Lower Thames Crossing

1.6 The Errata Report (Clean version)

DATE: October 2023
DEADLINE: 6

Planning Inspectorate Scheme Ref: TR010032
Application Document Ref: TR010032/APP/1.6

| Drawing Title | Figure 24 - Location of the Noise Attenuation Measures - Construction | | | | |

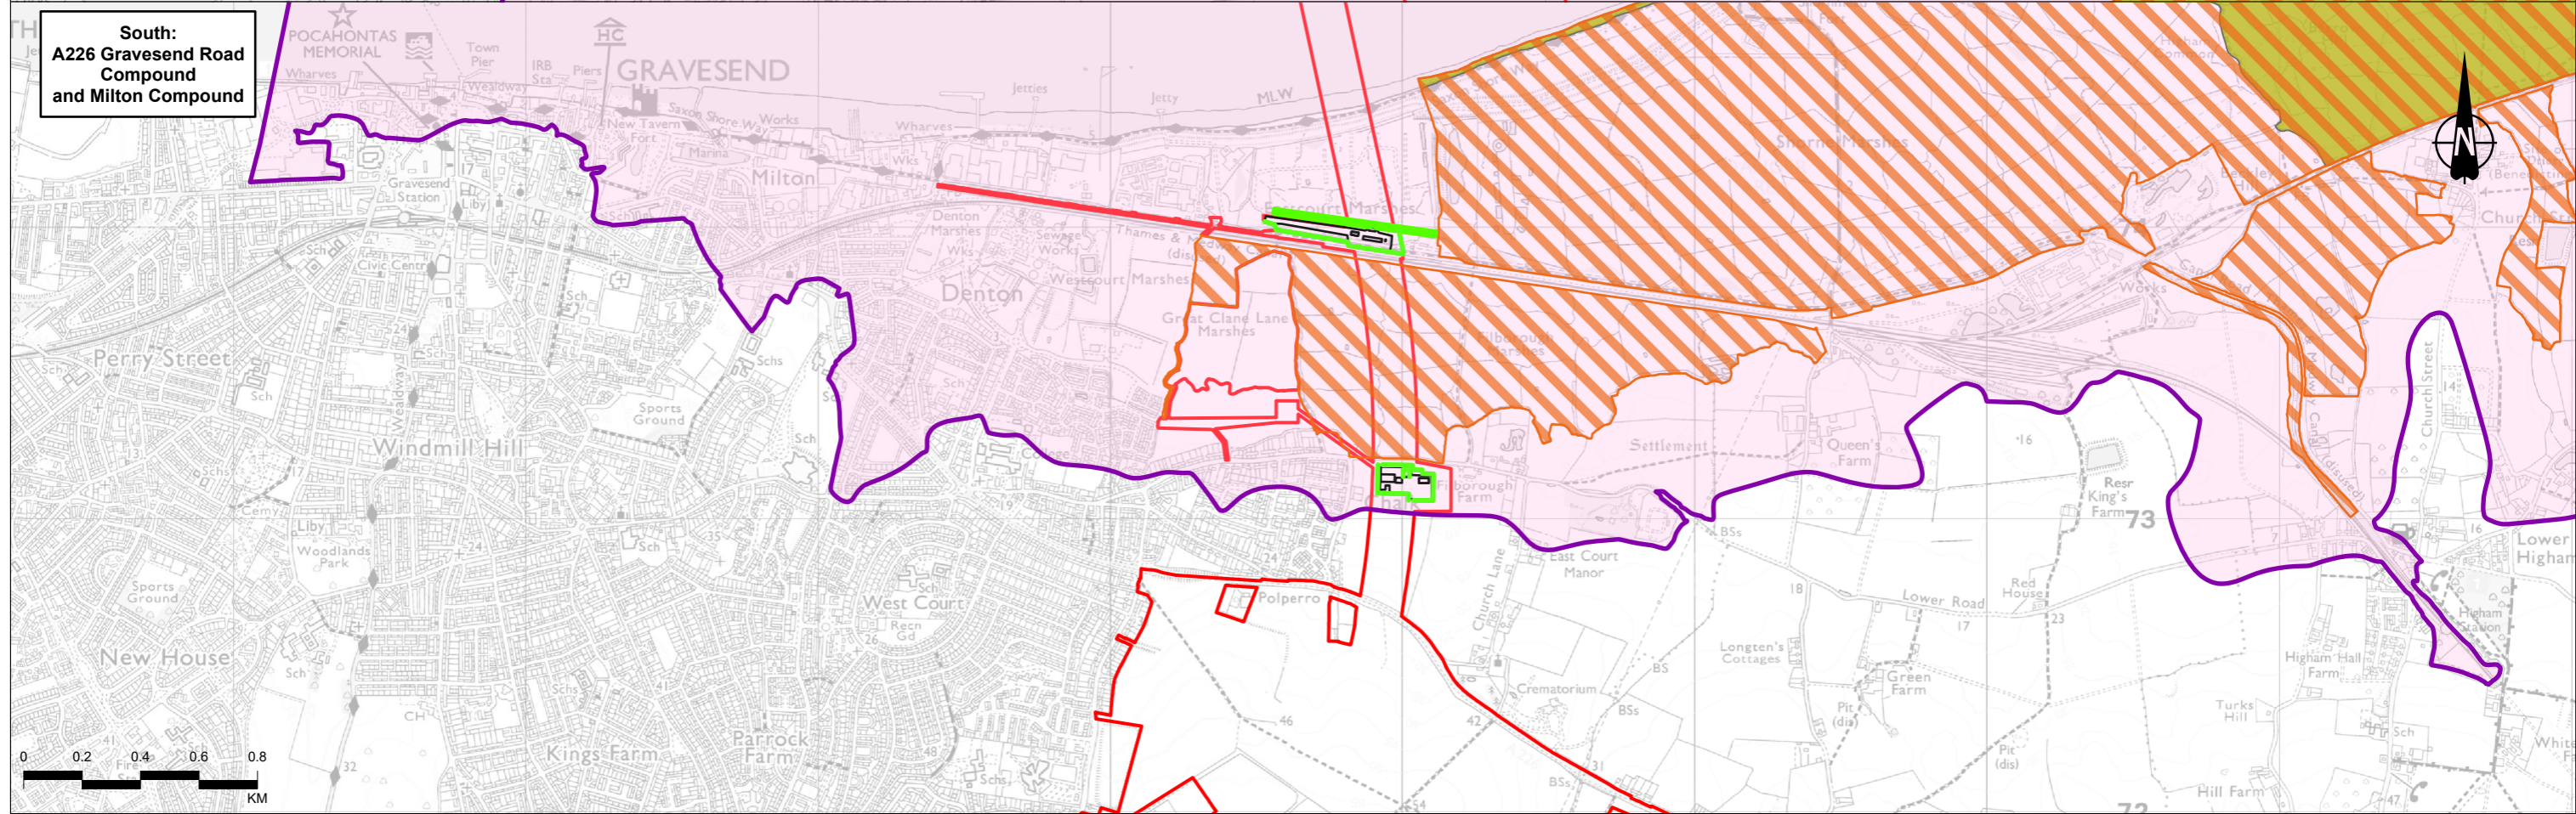
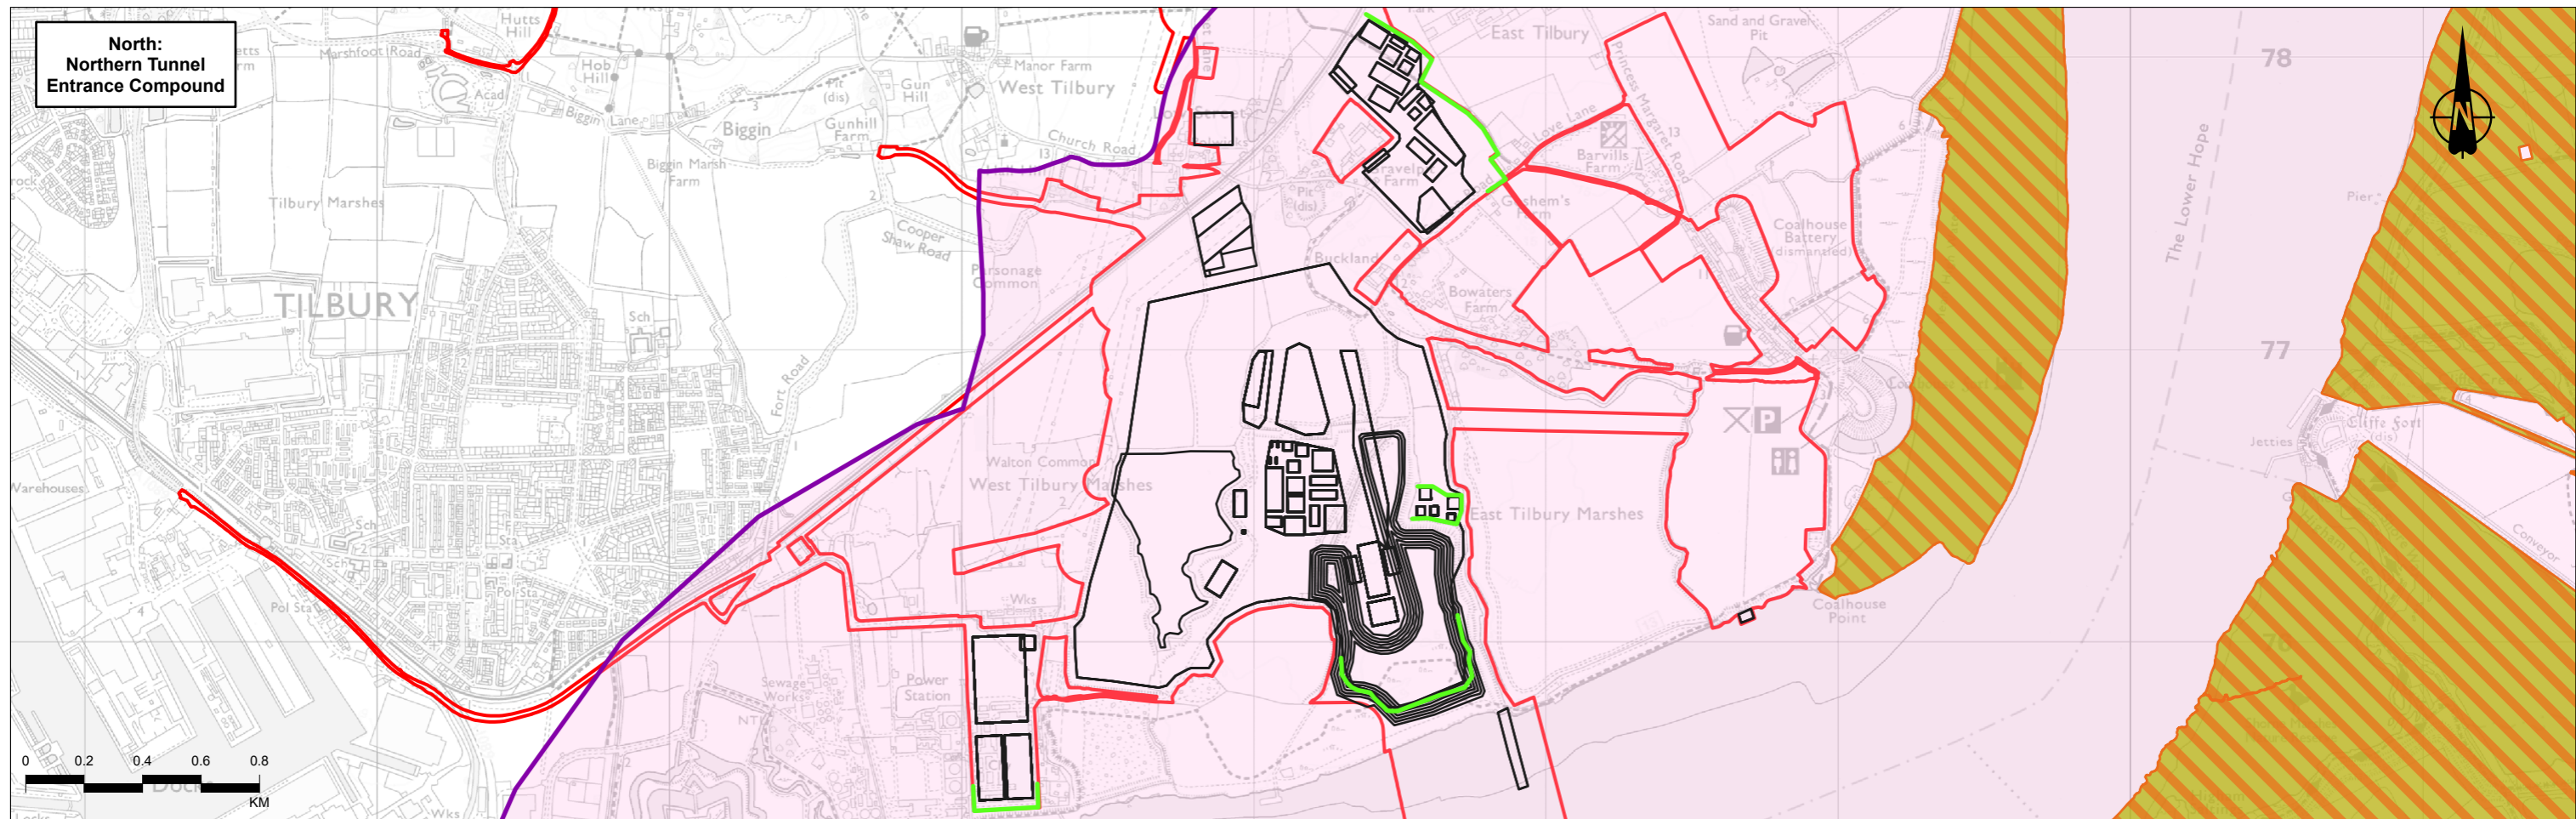
| Application Document Reference | Errata identified at | Document Name | Section (page, paragraph) | Nature of Erratum and explanation | Correction | Commentary for Deadline 6 |
|--------------------------------|----------------------|--|---|--|---|---|
| APP-487 | S51 Dec 2022 | Habitats Regulations Assessment Screening Report and Statement to Inform an Appropriate Assessment | Appendix A Figure 24 | North view not showing all of noise attenuation measures | North view rescaled to show all noise attenuation measures | Figure updated and found in Appendix A of this document. |
| APP-487 | D1 | Habitats Regulations Assessment - Screening Report and Statement to Inform an Appropriate Assessment | Figure 24 | Figure missing | Figure is cut off and does not include the full extent of proposed construction noise barriers | Figure updated and found in Appendix A of this document. |
